CCB 8247
Pre and Post Change Summary
PCN #:CBOL-24ZMOX279

Pre and Post Change Summary – 100L TQFP 14x14x1.0mm Carrier Tape Comparison

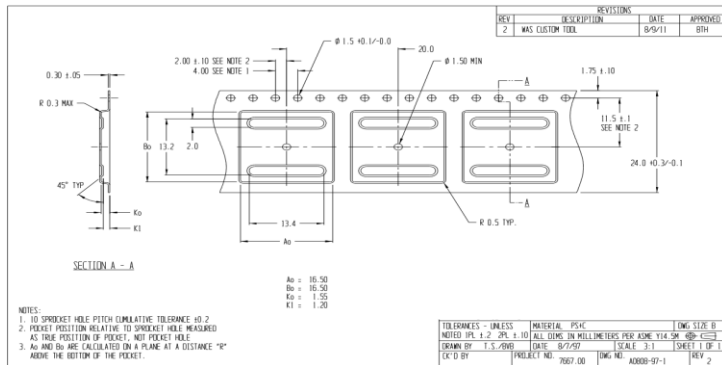
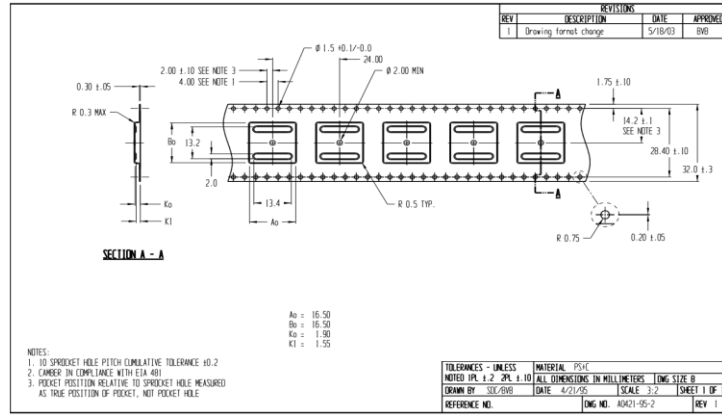
PRE CHANGE

POST CHANGE

W (mm.)	P (mm.)	A0 (mm)	B0 (mm)	K0 (mm)	K1 (mm)	Thickness (mm)
32.0±0.3	24.00±0.1	16.50±0.1	16.50±0.1	1.90±0.1	1.55±0.1	0.30±0.05
24.0+0.3/-0.1	20.00±0.1	16.50±0.1	16.50±0.1	1.55±0.1	1.20±0.1	0.30±0.05
24.0+0.3/-0.1	20.00±0.1	16.40±0.1	16.40±0.1	1.50±0.1	1.15±0.1	0.30±0.03
